City of Sugar Hill
Planning Staff Report
Central Business District Overlay (CBD) Design Review 16-01022

DATE: June 29, 2016; *Updated 7/7/2016*
TO: Mayor and Council, CBD Design Review Board
FROM: Planning Director
SUBJECT: Temple Drive/Hillcrest Drive/West Broad Street/ JWM Ventures LLC

Exhibit 1

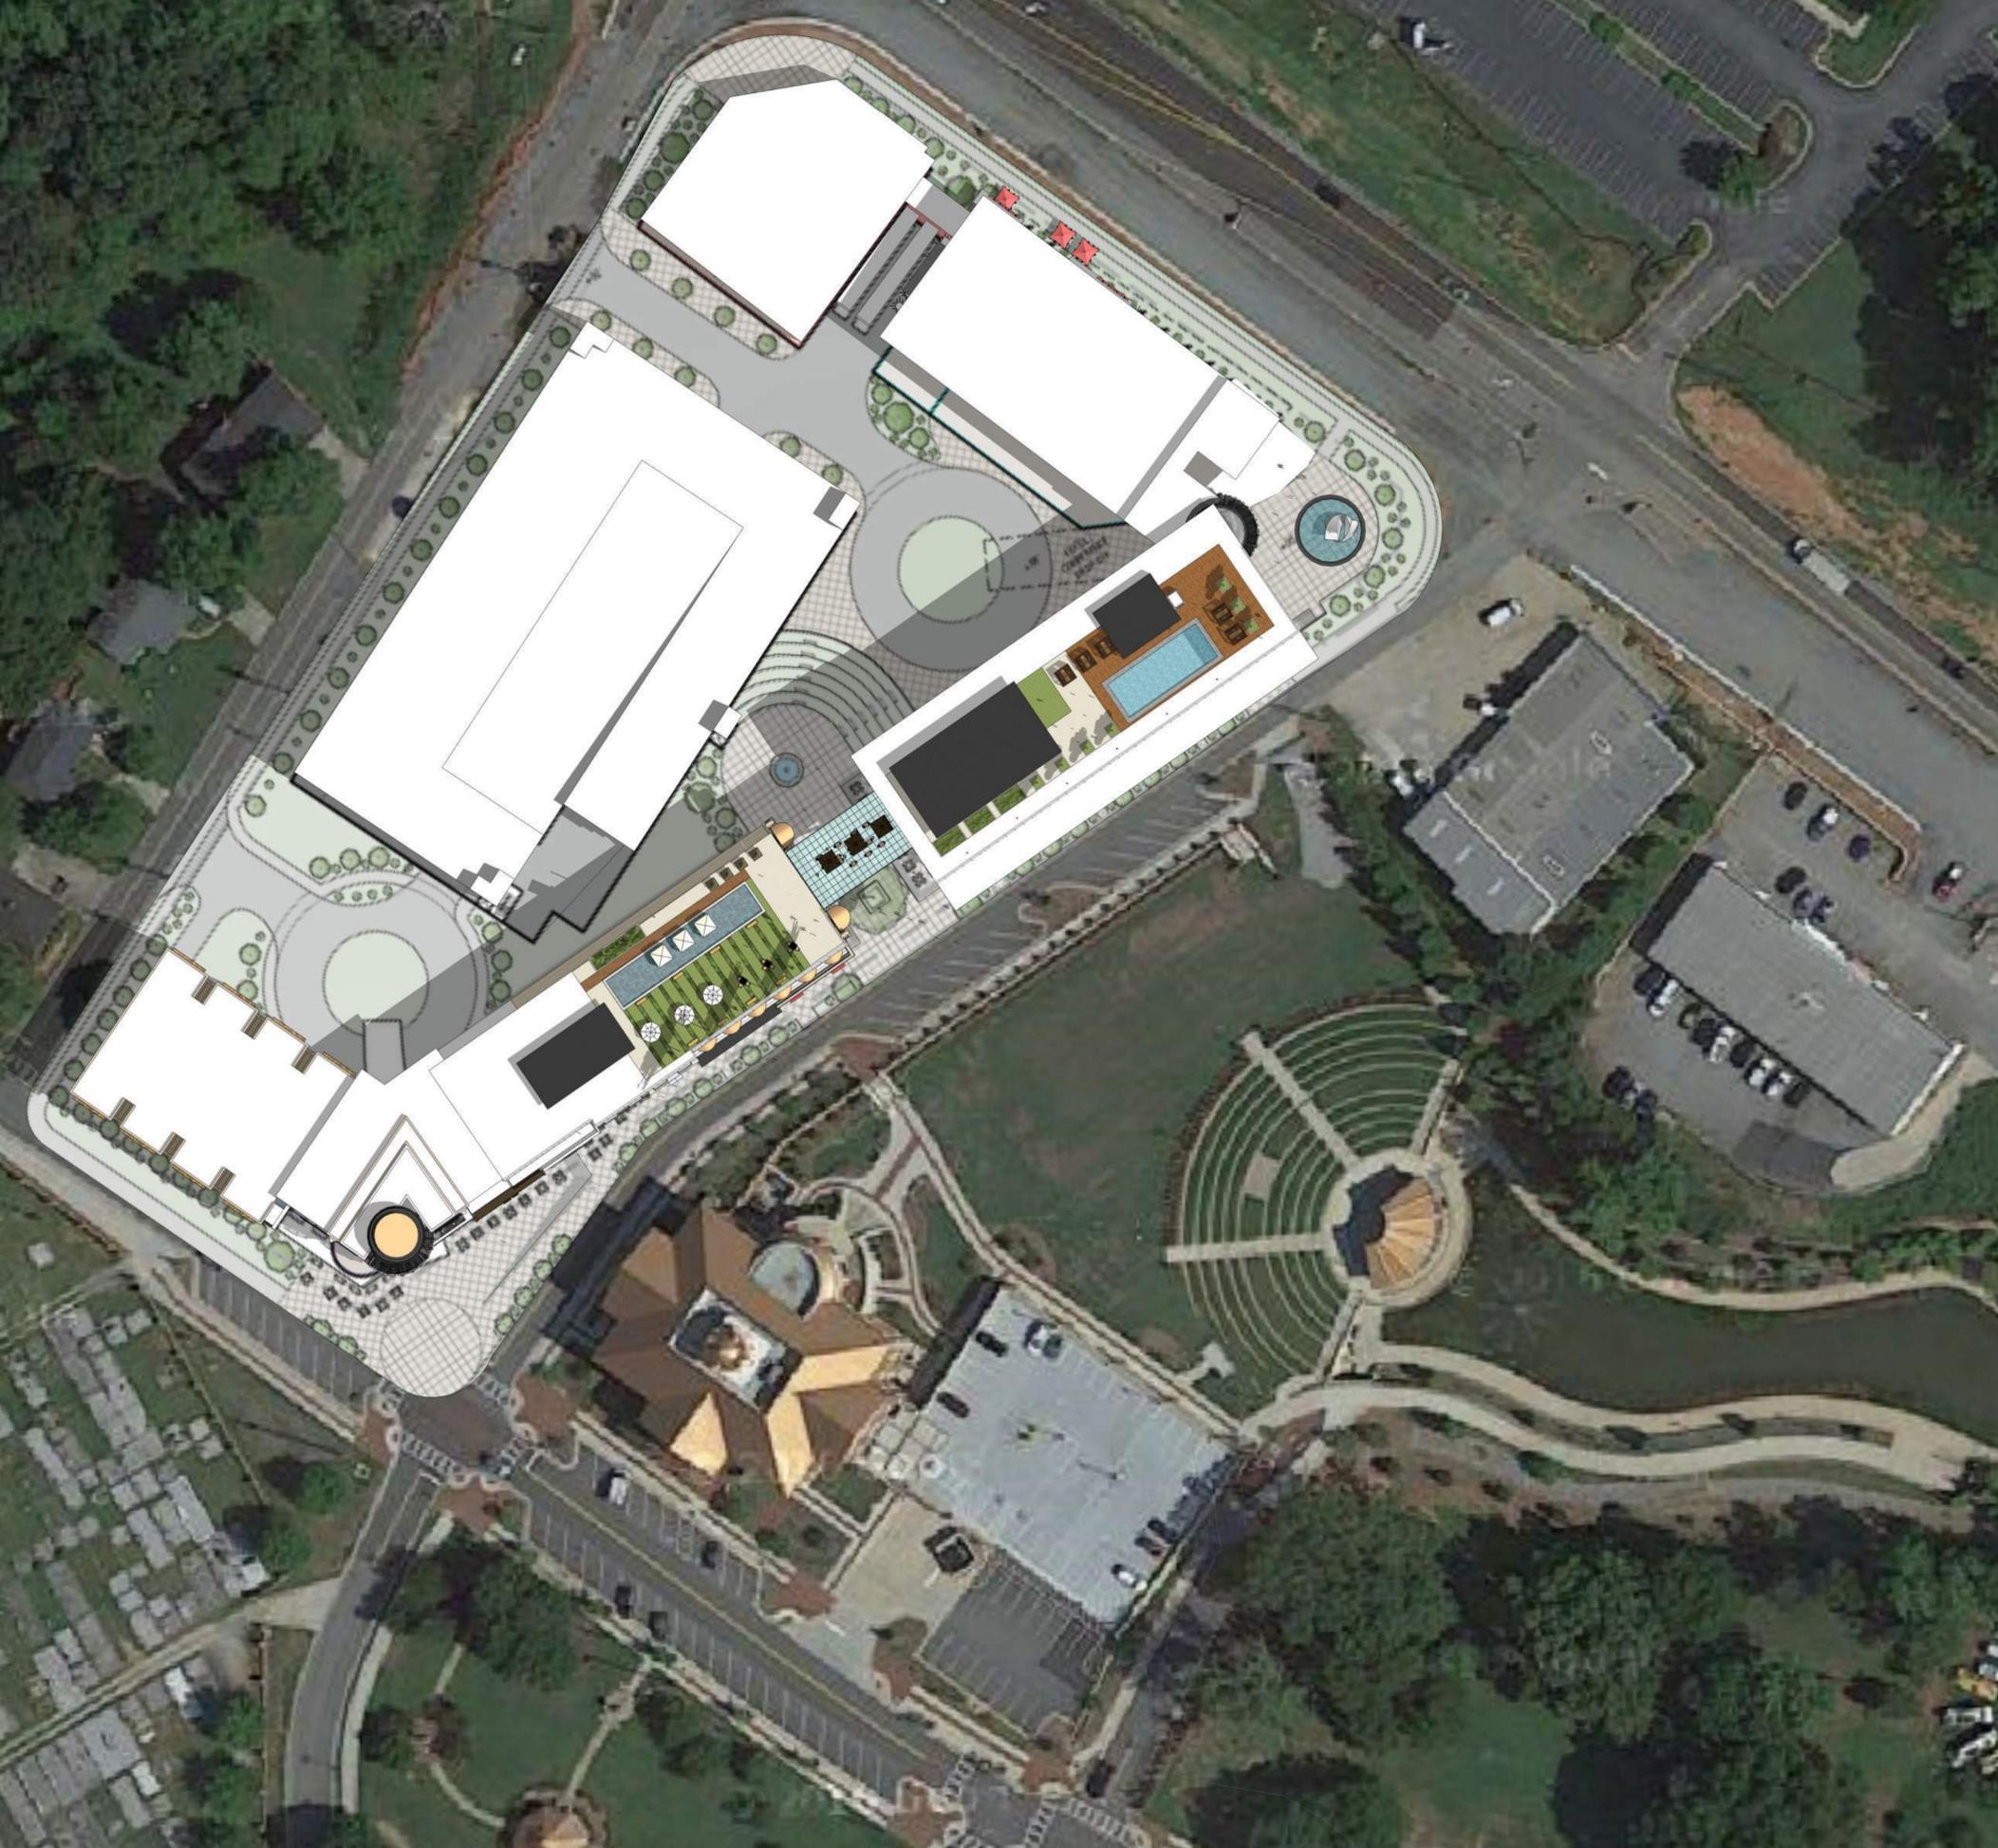
Approval of the site plan, hotel, conference, office and parking deck in material and architectural detail except building height. Final design shall substantially resemble the attached exhibits labeled Exhibit 1-4.

- The CBD location requires approval by the design review board.
- The building height exceeds the currently allowable heights and will require modification of the Central Business District overlay standards.
- The application otherwise adequately addresses the overlay design standards.
- Some elements should be further developed and refined.
- A few elements are not included in the design yet and will require separate consideration once completed.
